Groundwater Remedy Construction, PG&E Topock Compressor Station, Needles, California

Work Variance Request #10 – Revised Alignment for Pipelines C18 (East Ravine) and I1 (Bat Cave Wash), and Consolidation of Pipes/Conduits in the Southernmost Area of TCS

Date Submitted: 12/1/21

Variance Request No.: 10

WORK VARIANCE REQUEST #10 - PROPOSED REVISED CROSS SECTIONS FOR PIPELINES M1/M2/M2' (INSIDE TCS) RESULTING FROM CONSOLIDATION

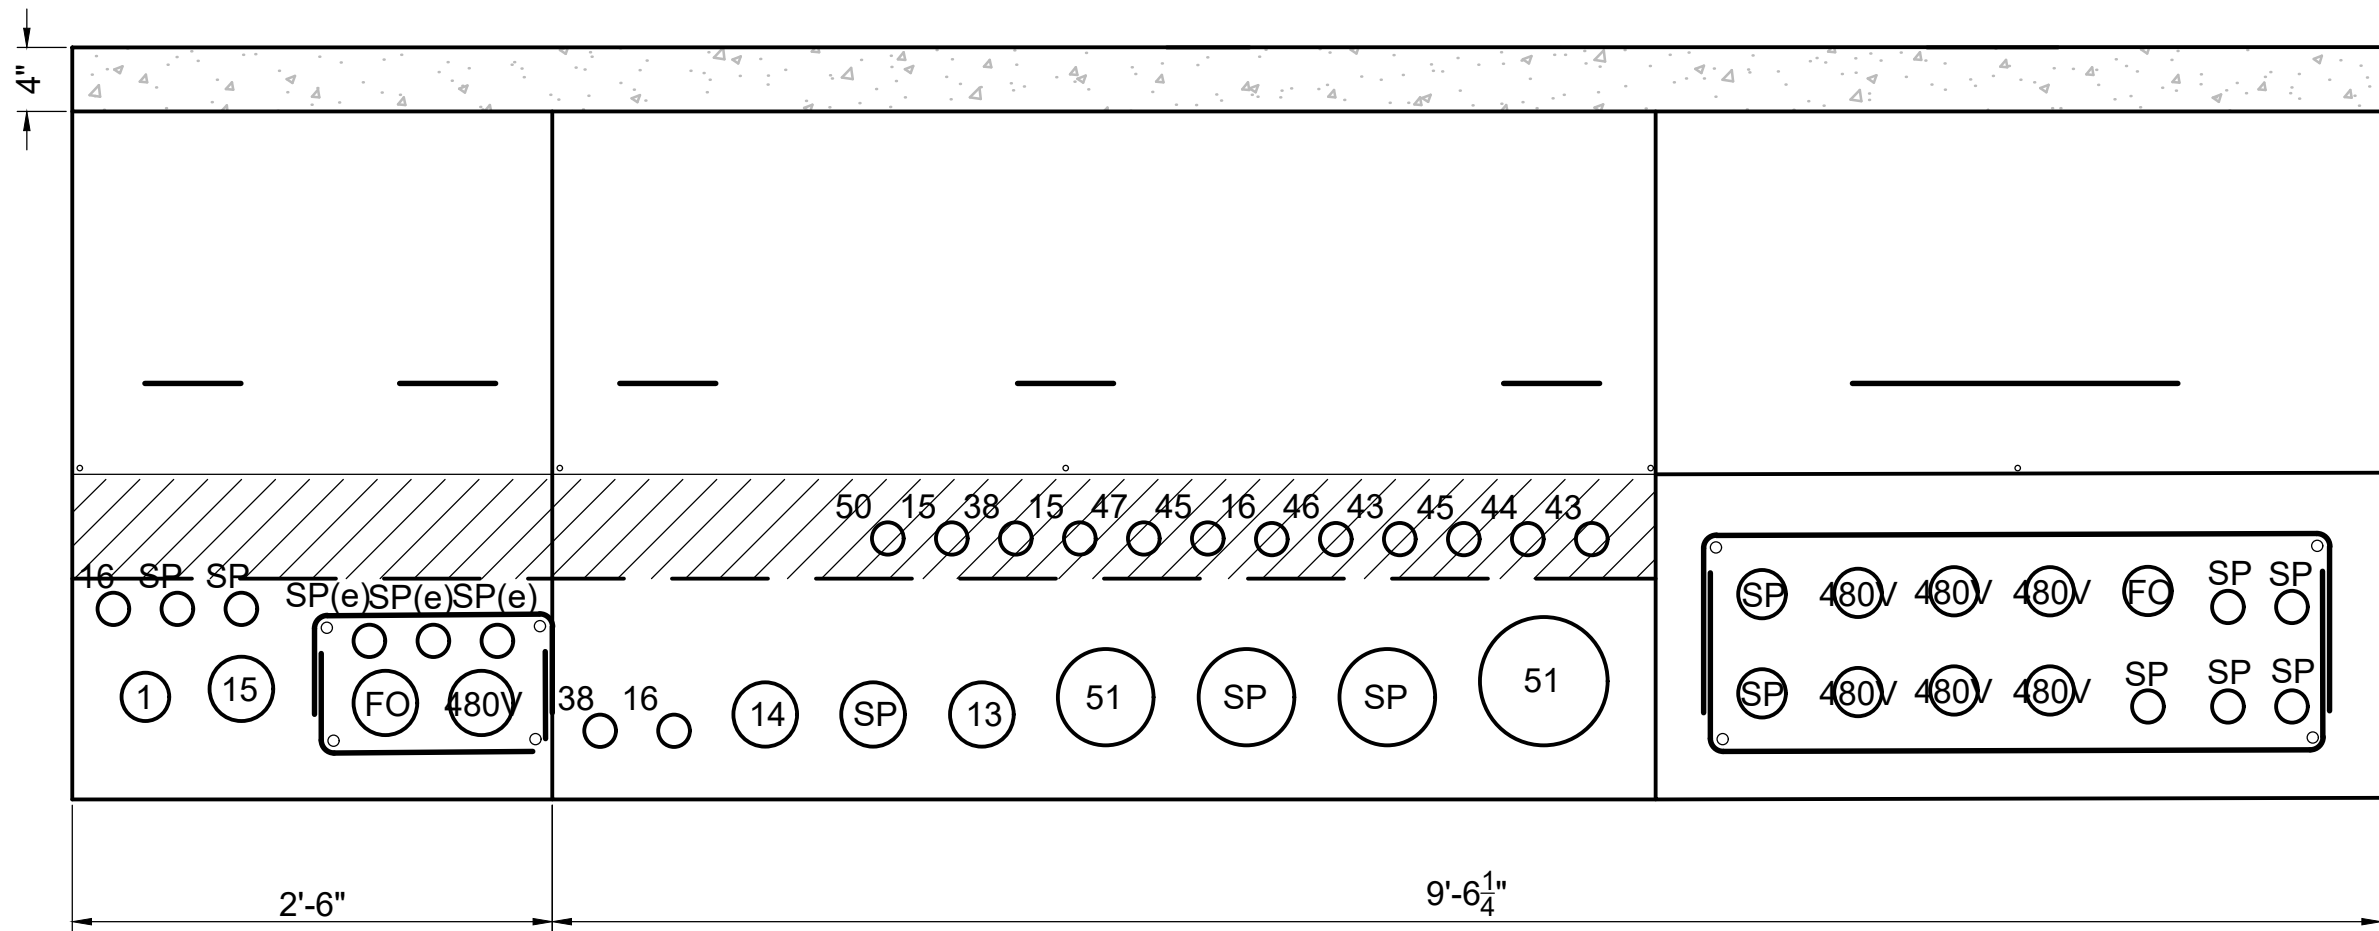
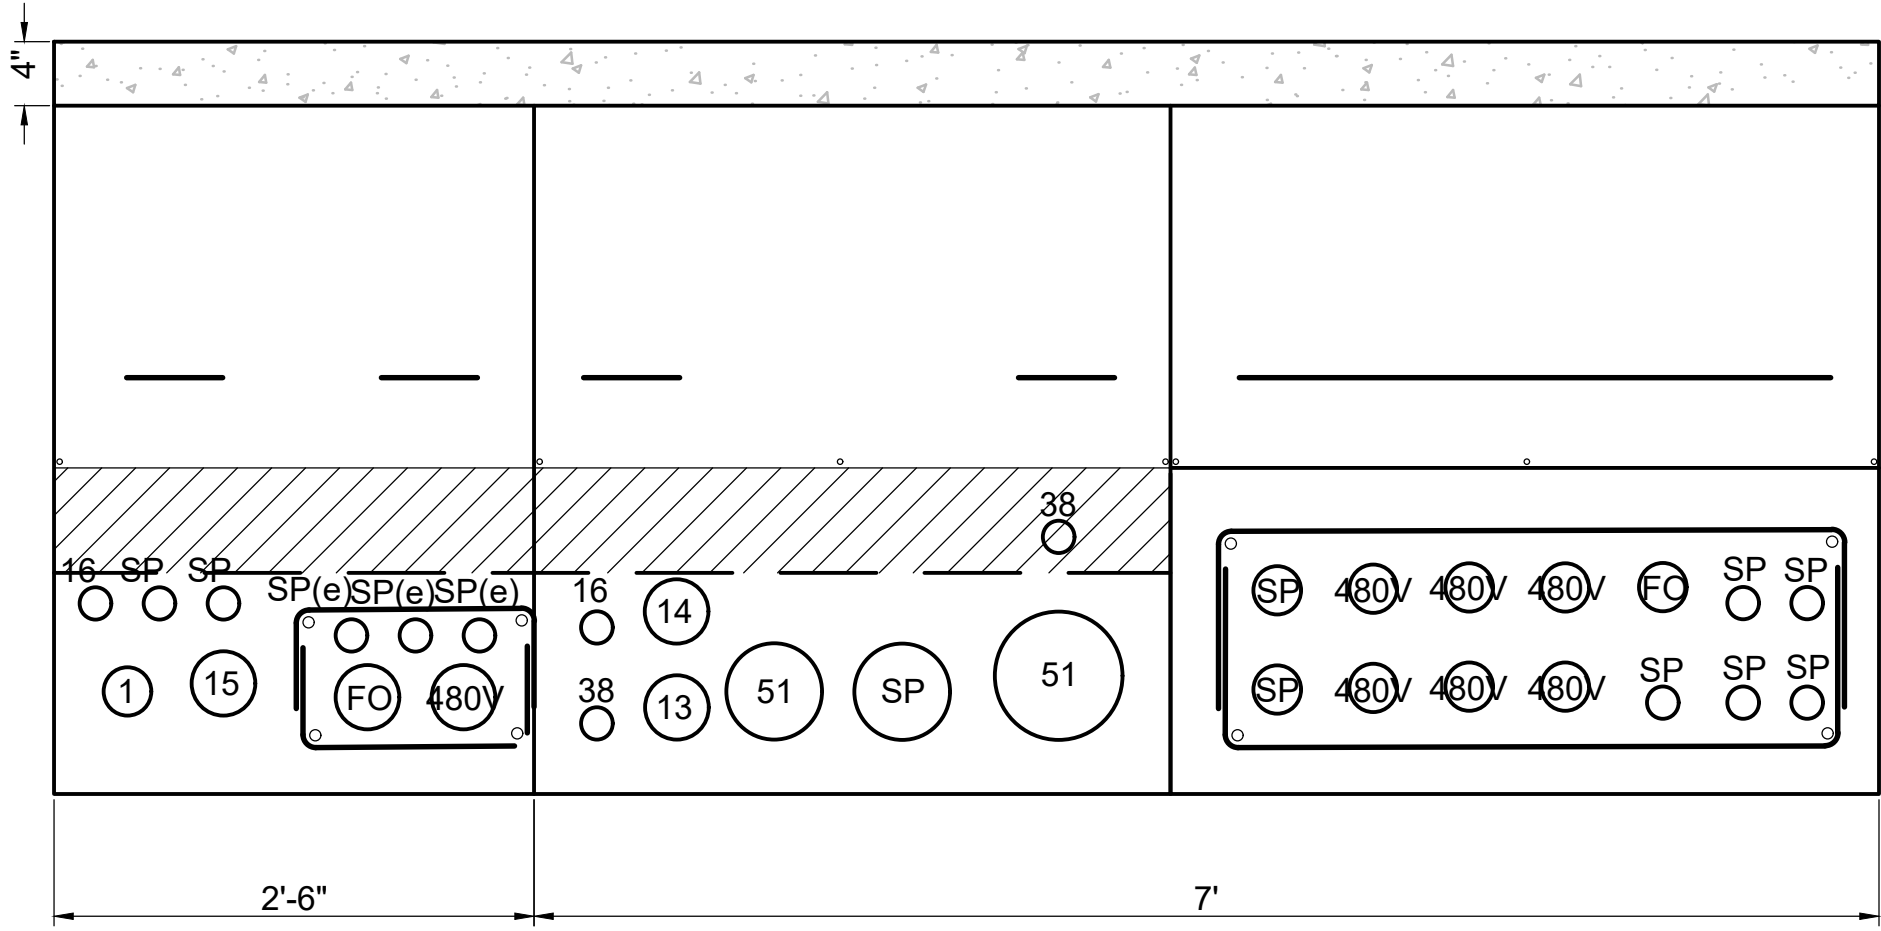
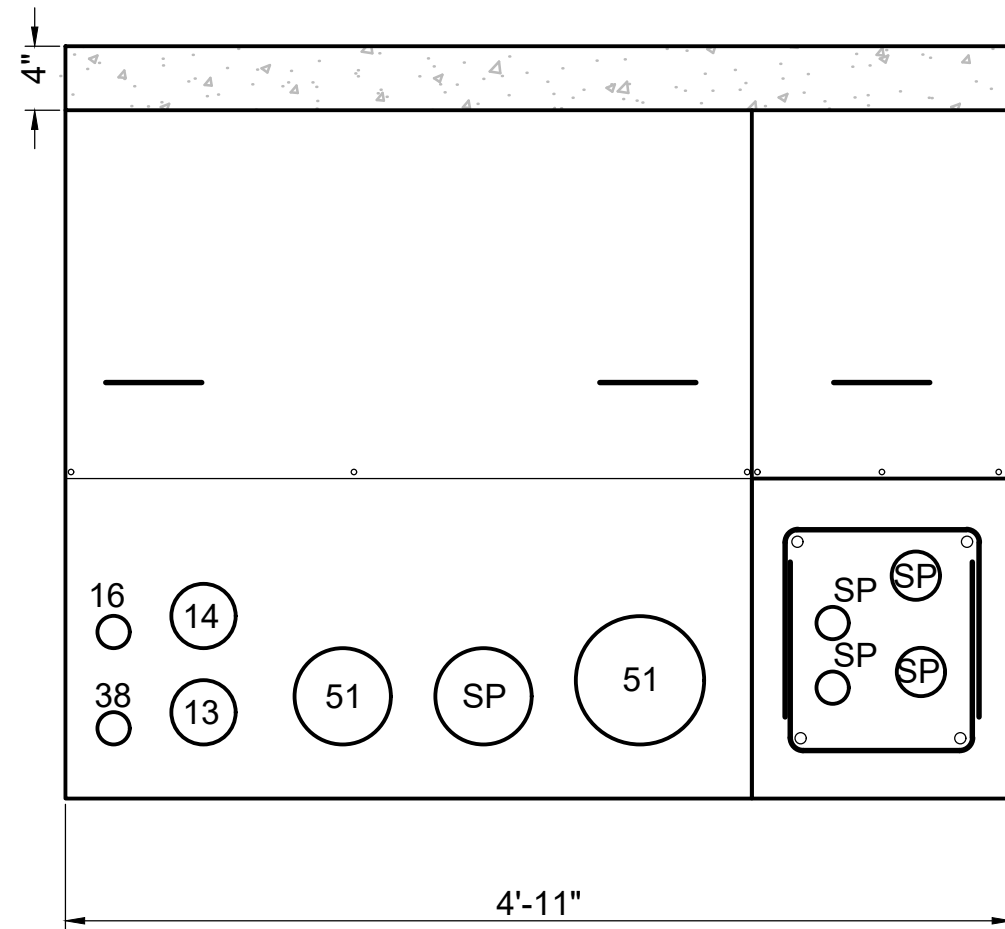
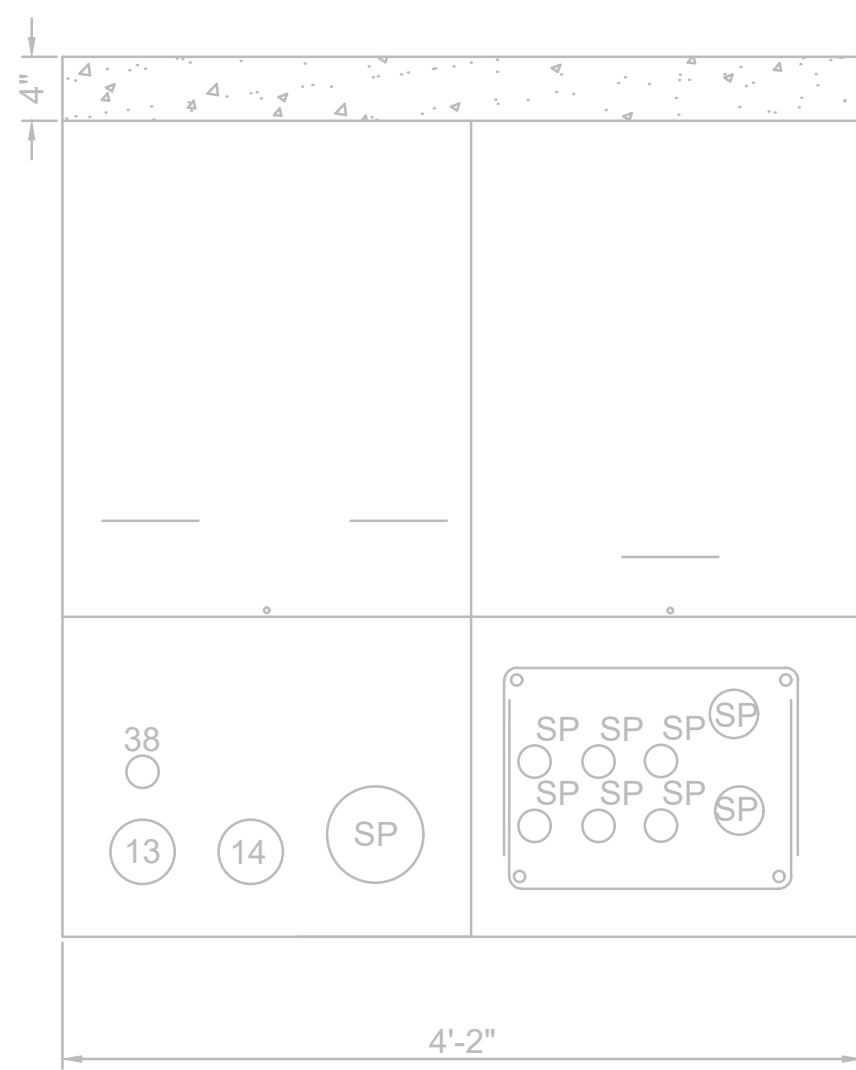
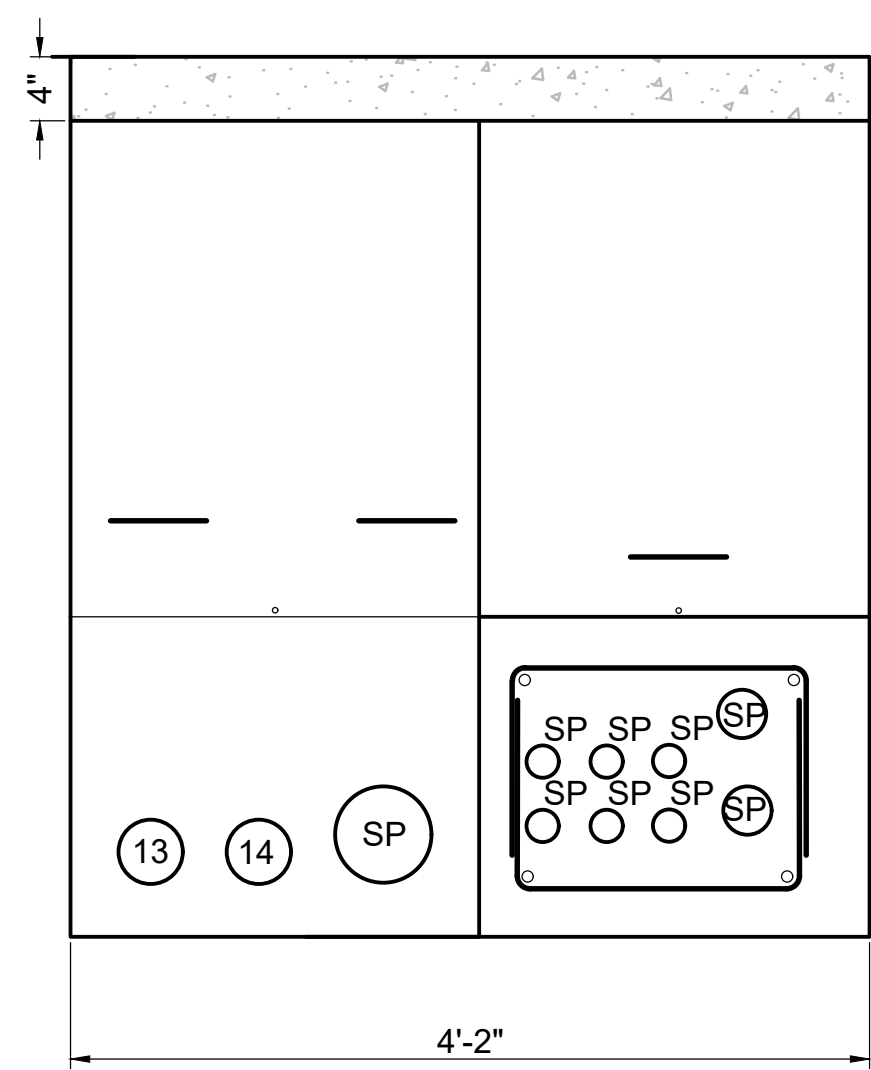
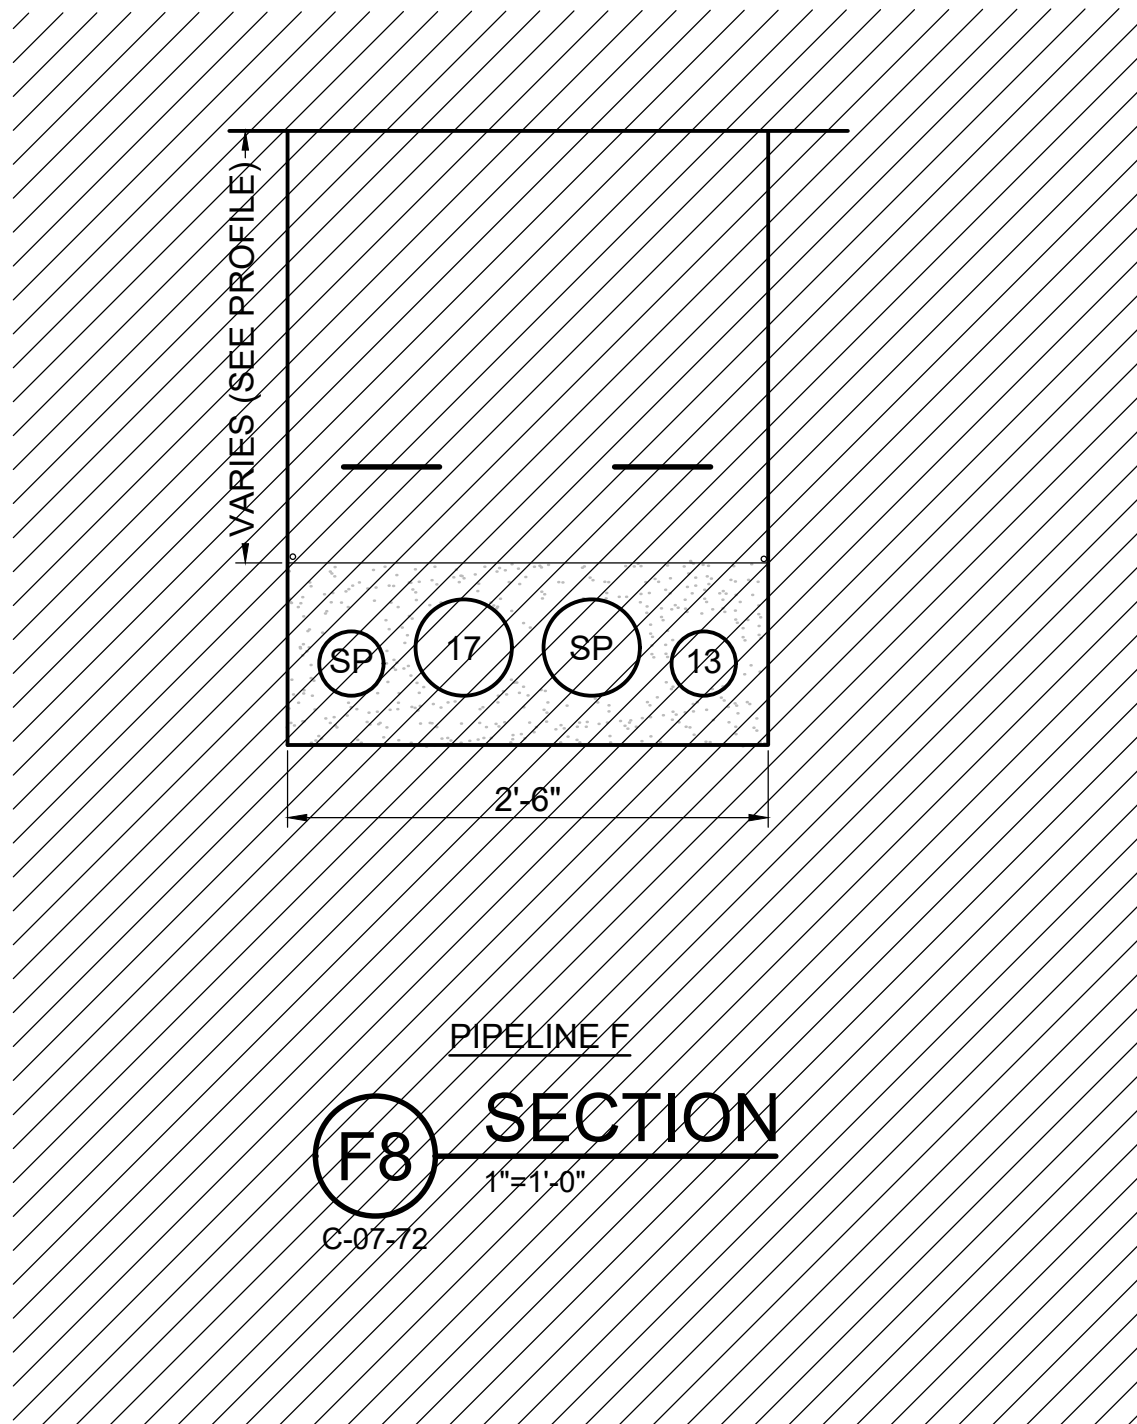
Consolidation of pipes/conduits in southernmost area of TCS into a central utility corridor – The two main revisions are 1) move all pipes/conduits from Pipelines D1, D2, L1, and L2 that are located south of the future remedy-produced water conditioning plant to the expanded M1 and M2 trenches, and 2) realign Pipeline L3 to connect with Pipeline K. Essentially, this move consolidates remedy piping/conduits in the southernmost area of TCS into a central utility corridor for a safer/easier construction (further away from PG&E's 300A gas pipeline and out of the rocky area) as well as ease of future maintenance (inside a common trench and utility corridor).
